File Number	Application Type	Decision Type
DEPN-23-0157	Major Modification	Quasi-Judicial

CSU WILSON TANK HEIGHT INCREASE

Planning Commission October 11, 2023

Staff Report by Case Planner: William Gray, Senior Planner

PLANT SCHEDULE

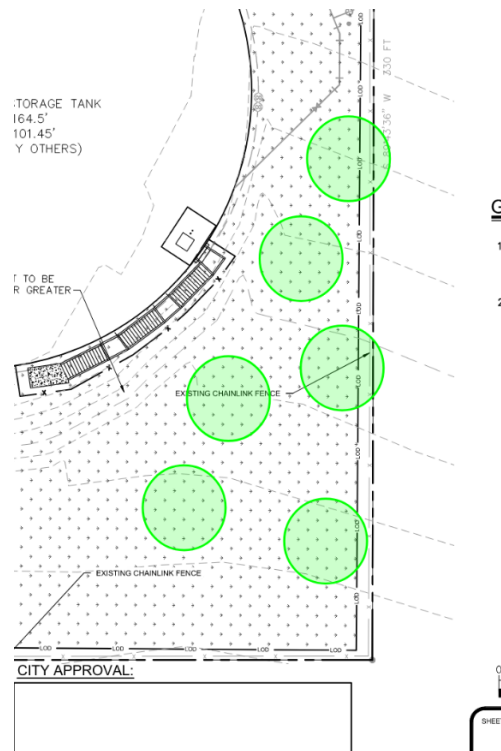
The new landscaping proposed with the amendment propose additional trees and increased tree sizes. Tree quantity increases to 35, types on trees provided include both Ponderosa Pines and Blue Spruce, and tree size is increased. The image below is the plant schedule for the proposed landscape plan.

The Applicant has stated that their preference for the larger trees is 35-feet. However, 35 feet evergreens cannot be guaranteed. A reason for this is the tree spade that is necessary to facilitate the transplant from nursery to site. The increase in quantity and height compared to the original development plan will have a much more immediate impact to screening and buffering for the adjacent neighbors. It is a better outcome than previously approved.

1. The size range of 25' – 35' listed for the larger Ponderosa Pine or Colorado Blue Spruce trees in the Plant Schedule under the Botanical/Common Name column that is contained on the Landscape Plan is revised to 25' HGT. MIN. to match the Size/Cal. column.

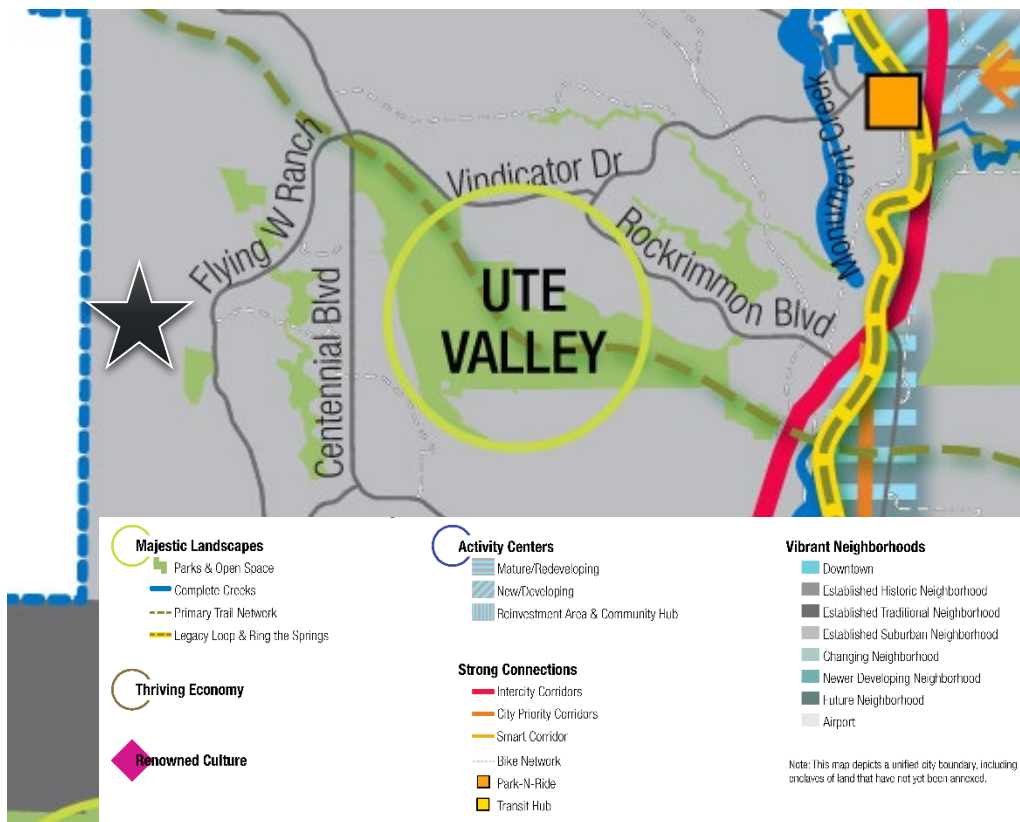
There is an additional area that City Planning would like to see addressed on the landscape plan. Addressing visual impacts are challenging, particularly when a structure can be viewed from many vantage points. City Planning has always evaluated the impacts of the project from the viewpoint of the most impacted properties. This is not said in a way to protect view, but more to ensure that the structure blends with the landscaping. It is obviously the residence immediately east of the site. The other is Flying W Ranch. From Flying W Ranch headquarters the water tank skylines. This is

particularly harder to address but should be treated in a similar manner as done with the properties to the east of the site. The picture at the bottom of page 9 shows how the water tank skylines. Additional landscaping should be placed in southwest corner of the site to provide mitigation for the skyline effect. The recommended placement of the landscaping is

shown below. These six (6) recommended trees need to be a minimum of 25 feet in height and can be either Ponderosa Pines or Colorado Blue Spruce.

6. The landscape plan is revised to include six (6) additional 25 feet minimum height Ponderosa Pine or Colorado Blue Spring in the southwest corner of the site (see illustration on Page 11).
